CLASS 2 PERMIT MODIFICATIONS TO 325 HAZARDOUS WASTE TREATMENT UNITS (HWTUs) AND TEMPORARY AUTHORIZATION REQUEST

CLASS 2 PERMIT MODIFICATIONS TO 325 HAZARDOUS WASTE TREATMENT UNITS AND TEMPORARY AUTHORIZATION REQUEST

Hanford Facility RCRA Permit Modification
Part III, Chapter 6 and Attachment 36
325 *Hazardous Waste Treatment Units*

Figure. 2-2. Location of 325 HWTUs – Ground Floor Areas.

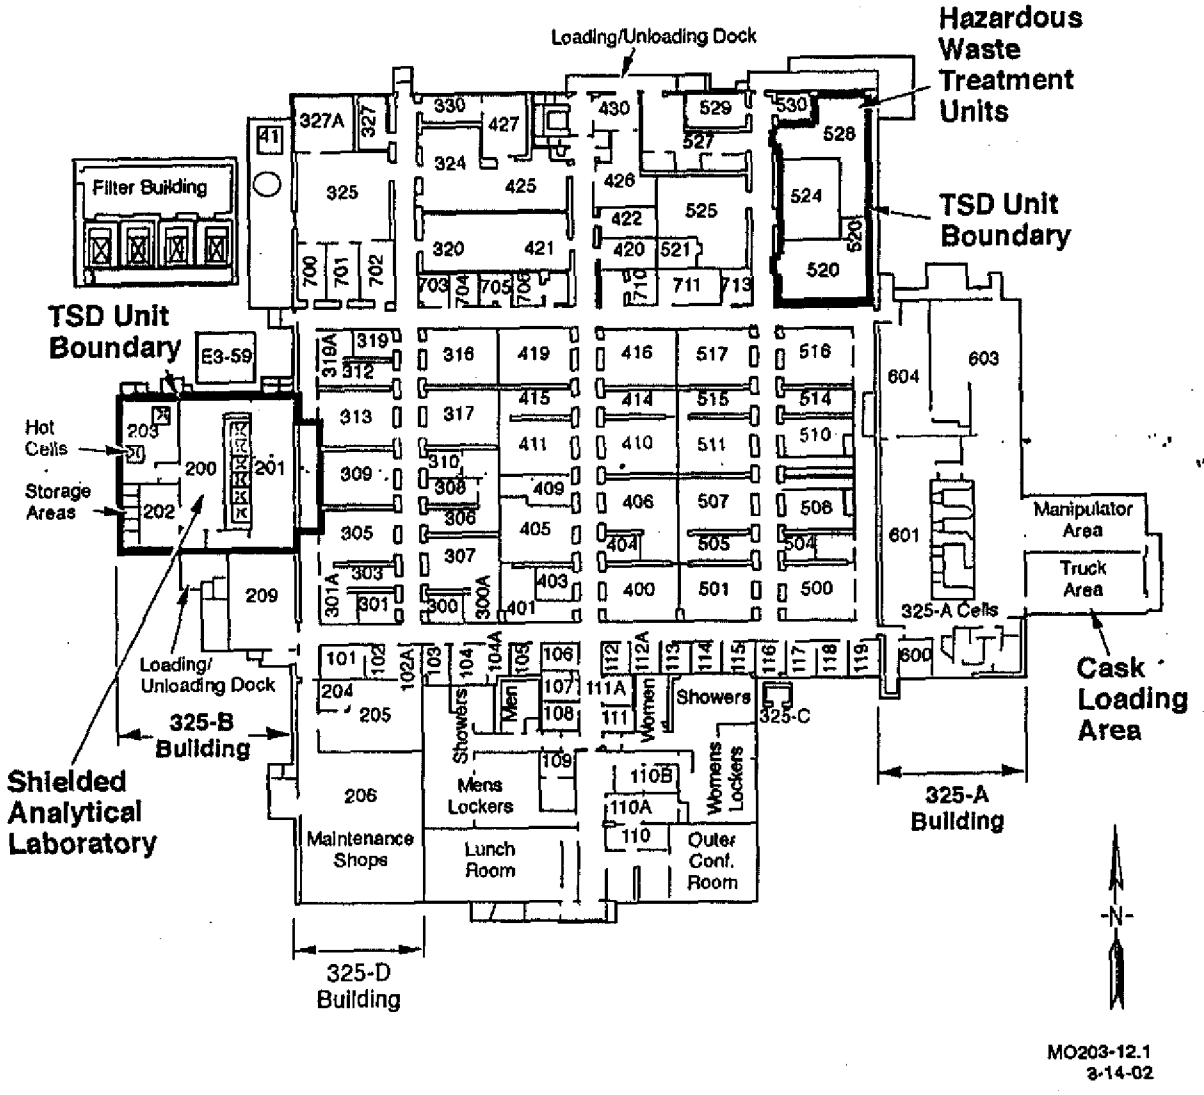
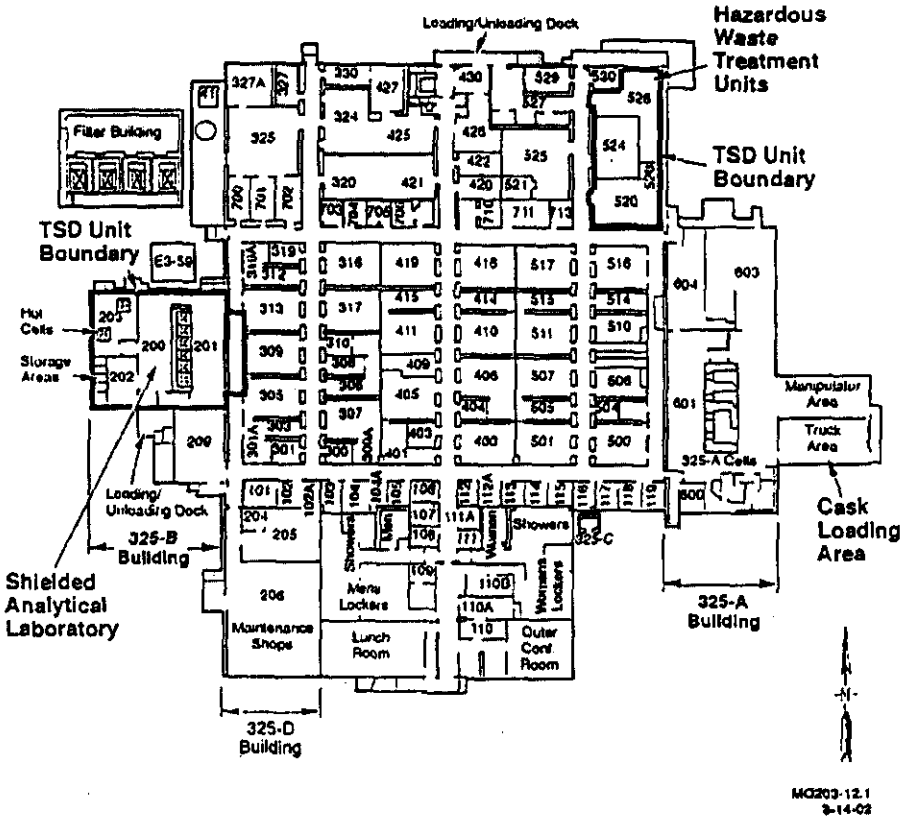
The HWTU consists of ~~two~~ three rooms (Rooms 520, 524 and 528) located in the northeast corner of the main floor of the 325 Building. Dangerous waste is stored and/or treated in ~~two~~ three of the rooms (Rooms 520, 524 and 528). The storage of containers in the HWTU for greater than 90 days is conducted in compliance with WAC 173-303-630. A plan drawing of the HWTU is provided as Figure 2.~~5~~6.

Figure 4-1. Hazardous Waste Treatment Unit Secondary Containment System

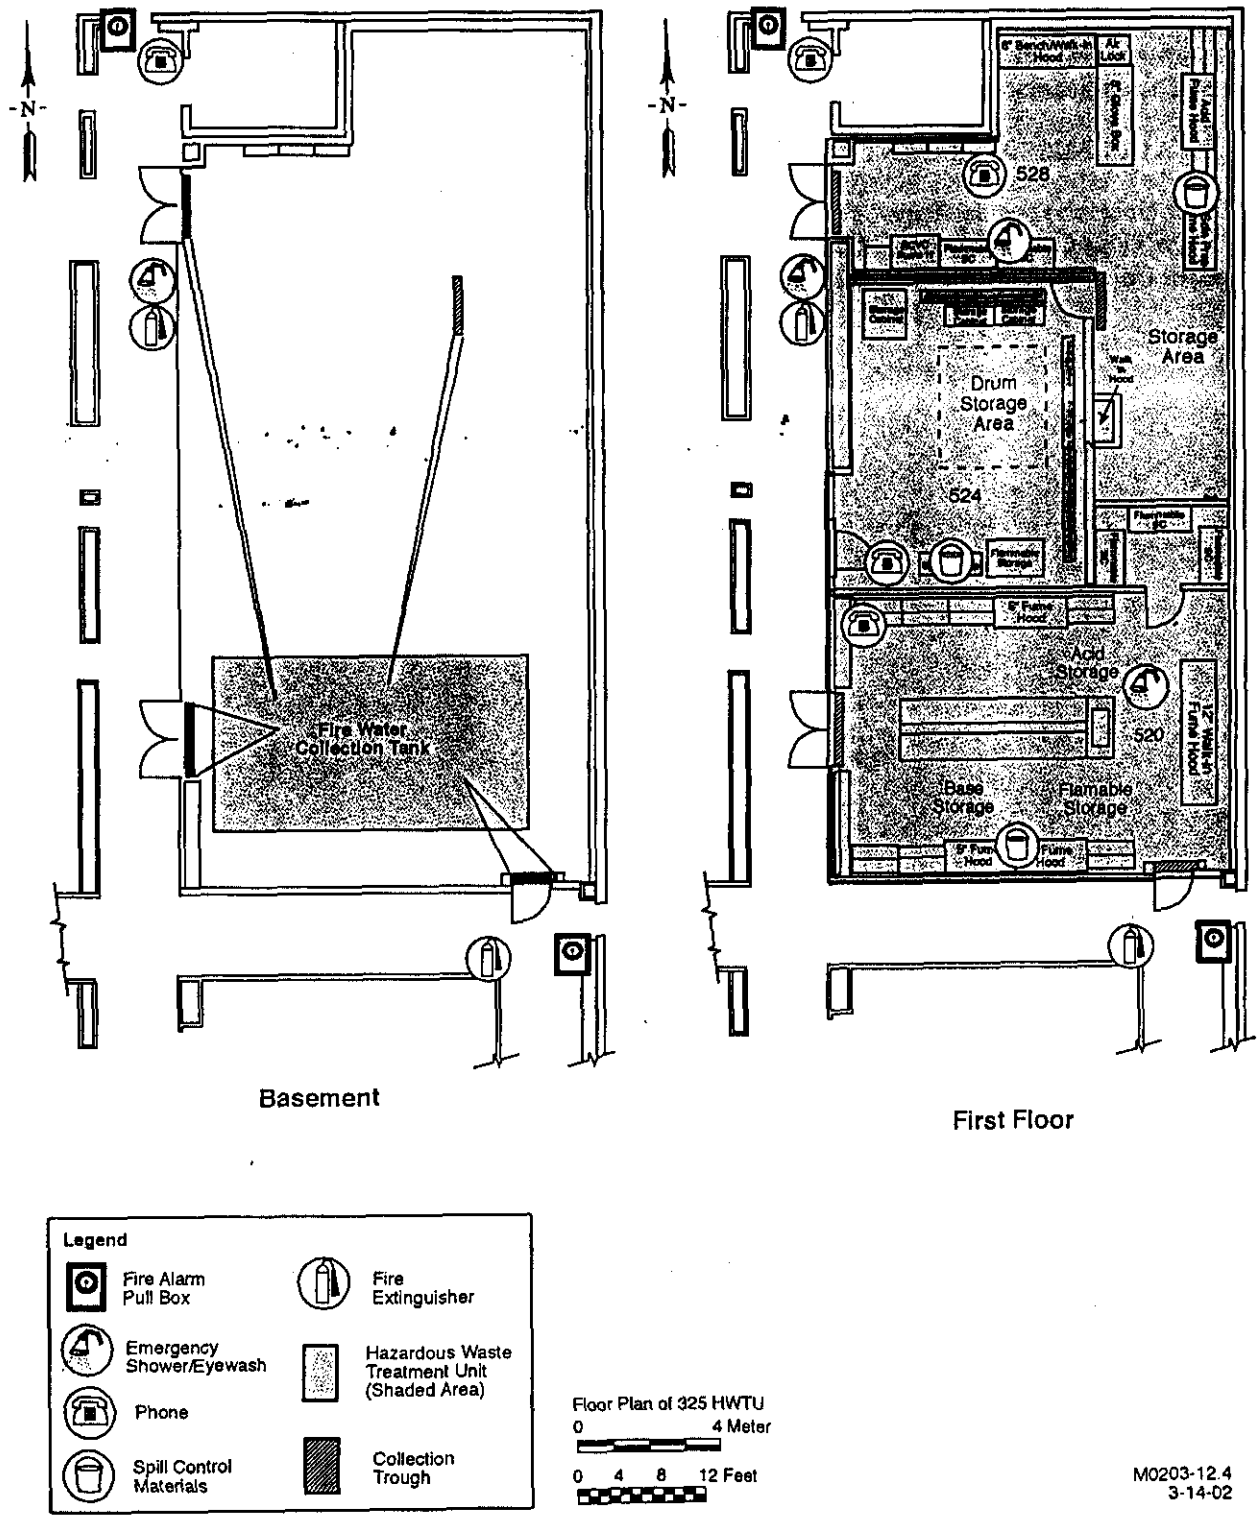
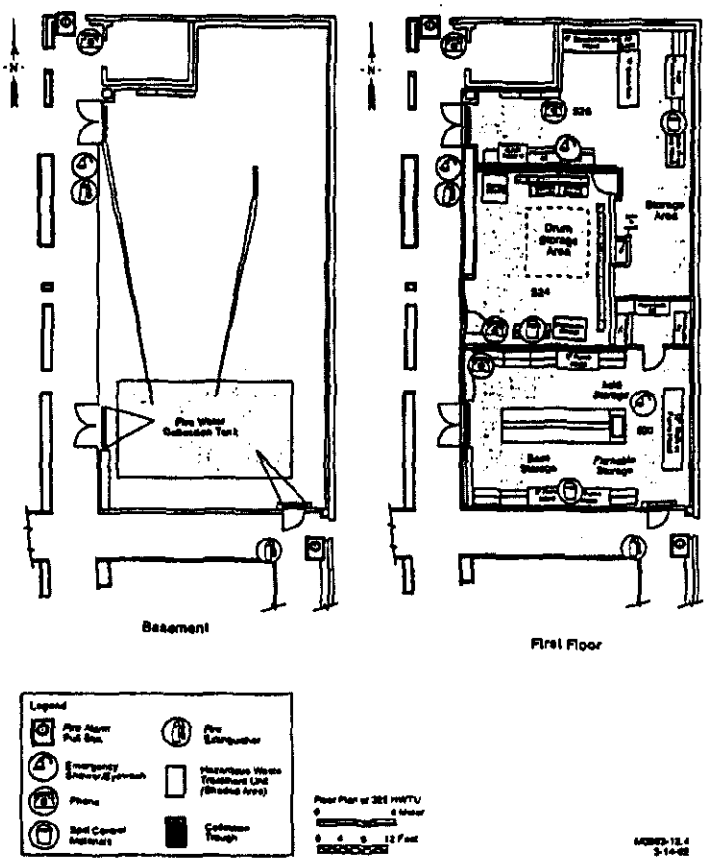
Major spills or leaks of liquid mixed waste flow into the fire water containment system. The fire water containment system consists of floor trenches located at each entrance to ~~the rooms~~ 520 and 528 and the fire water containment tank located in the basement of the building. The system is designed to collect the fire-suppression water in the event that the automatic sprinkler system was activated. The location of the trenches is shown in Figure 4.1.

Figure 6-1. Locations of Emergency Equipment at the Hazardous Waste Treatment Units

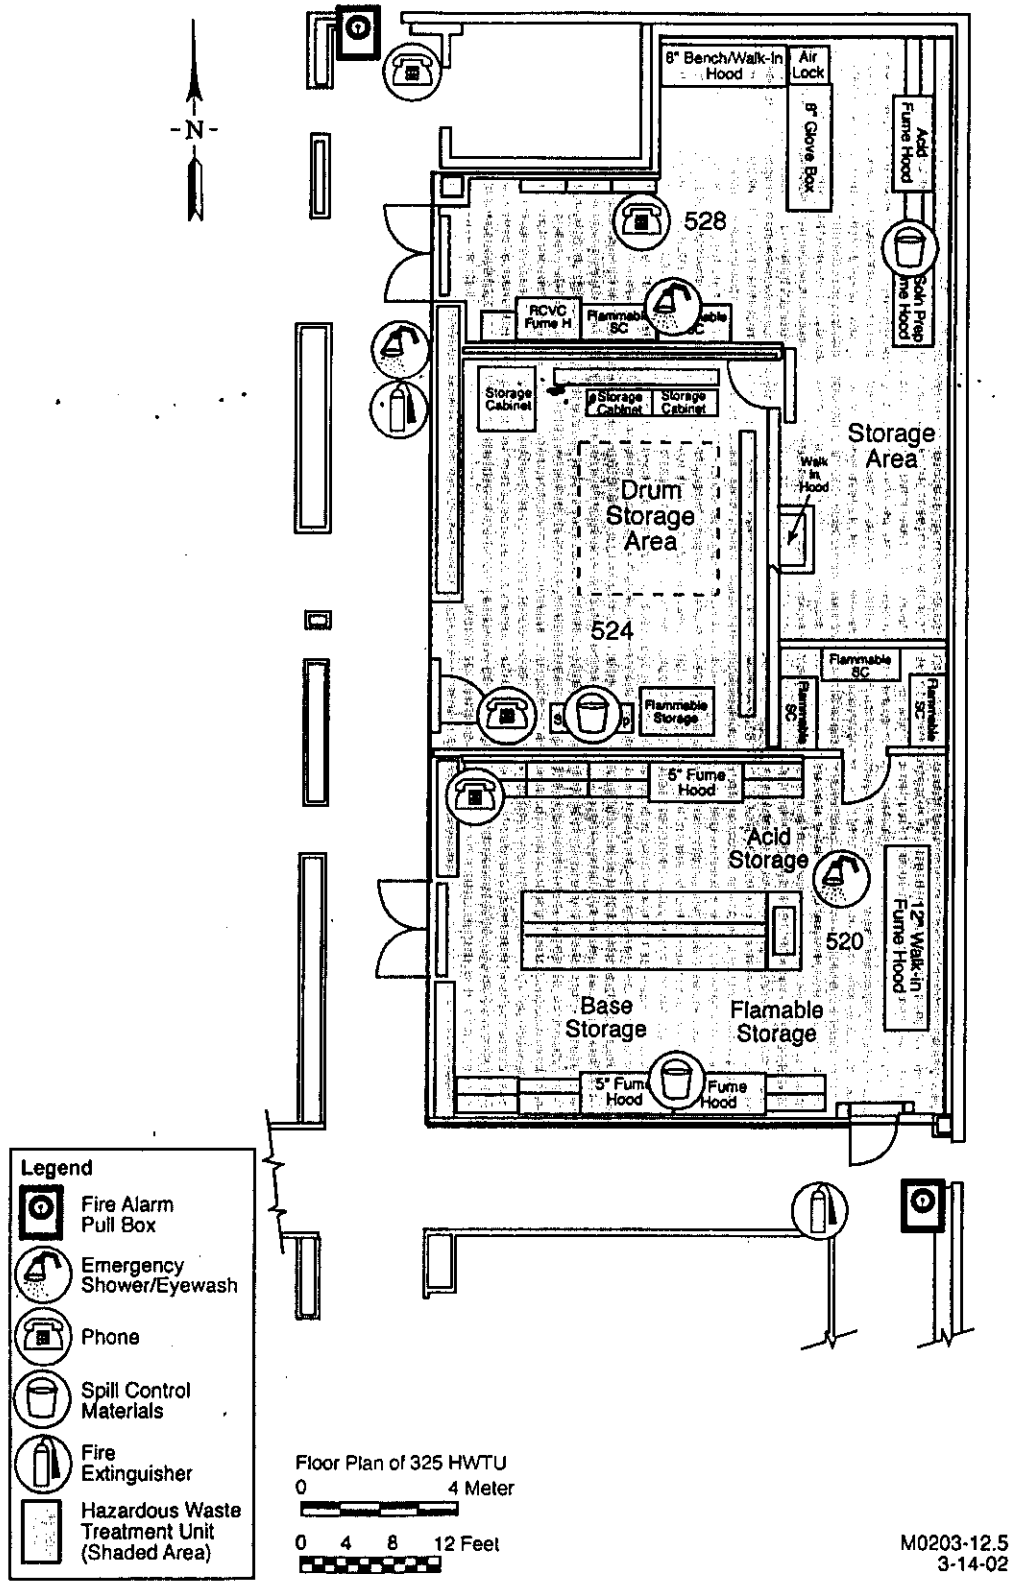
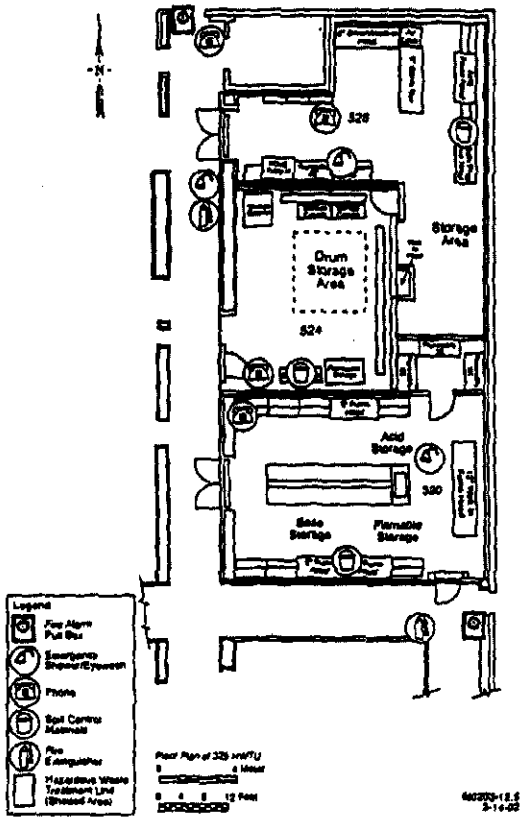
Two portable 4.5 kilogram ABC fire extinguishers are available adjacent to the HWTU as shown in Figure 6-1. The portable fire extinguishers are located in the hall ~~between the entrances to Rooms 528 and 520~~ outside the entrance to Room 524 and in the hall south of the south entrance to Room 520.
